Access Compliance Report

Public Rights-of-Way

(Curb Ramps)

Intersection ID: 8552	Main Street: GARNETTE_PL	Cross Street: MITCHELL_ST	Location: SE
ADA ID: 5E110DA10B7E	Ramp Type: Combination1	Initial Pass/Fail: Fail	Overall Compliance: No
Severity Score: 58.75			
Codes/Mitigation Info/Possible Solution		Field Measurements/Component Compliance

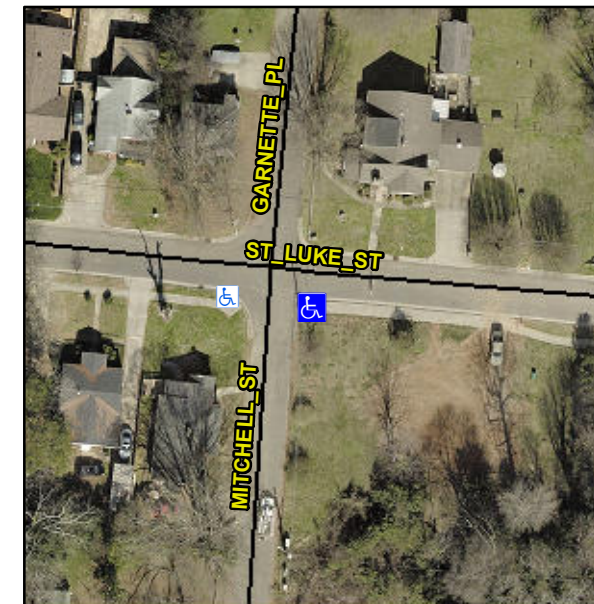
NO RT SW

Not Found, R304.5.1, R304.5.3, R304.3.2

Compliance	Description	Data	Compliance	Description	Data
N/A	Ramp Length LT (in)	33.0	N/A	Ramp Length RT (in)	36.0
Yes	Ramp Width LT (in)	72.0	Yes	Ramp Width RT (in)	72.0
Yes	Ramp Slope LT (%)	5.8	No	Ramp Slope RT (%)	17.3
Yes	Ramp XSlope LT (%)	0.6	Yes	Ramp XSlope RT (%)	0.9
N/A	Ramp Length (in)	71.0	Yes	Ramp Slope (%)	1.9
No	Ramp Width (in)	46.5	No	Ramp XSlope (%)	9.5
N/A	Flare Type LT	N/A	N/A	Flare Type RT	N/A
N/A	Flare Slope LT (%)	N/A	N/A	Flare Slope RT (%)	N/A
N/A	Flare Traversable LT?	N/A	N/A	Flare Traversable RT?	N/A
N/A	Landing Length (in)	N/A	N/A	DWS Provided?	N/A
N/A	Landing Width (in)	N/A	N/A	DWS Contrast?	N/A
N/A	Landing Slope (%)	N/A	N/A	DWS Length (in)	N/A
N/A	Landing X Slope (%)	N/A	N/A	DWS Full Width?	N/A
N/A	Landing Curb? (Y/N)	N/A	N/A	DWS Offset (in)	N/A
N/A	Shared Landing?	N/A			
N/A	Gutter Ponding?	N/A	N/A	Gutter Slope (%)	N/A
N/A	Gutter Lip Ht (in)	N/A	N/A	Gutter X Slope (%)	N/A
N/A	Painted X Walk1?	No	N/A	Painted X Walk2?	N/A

Remove & Replace Entire Ramp.
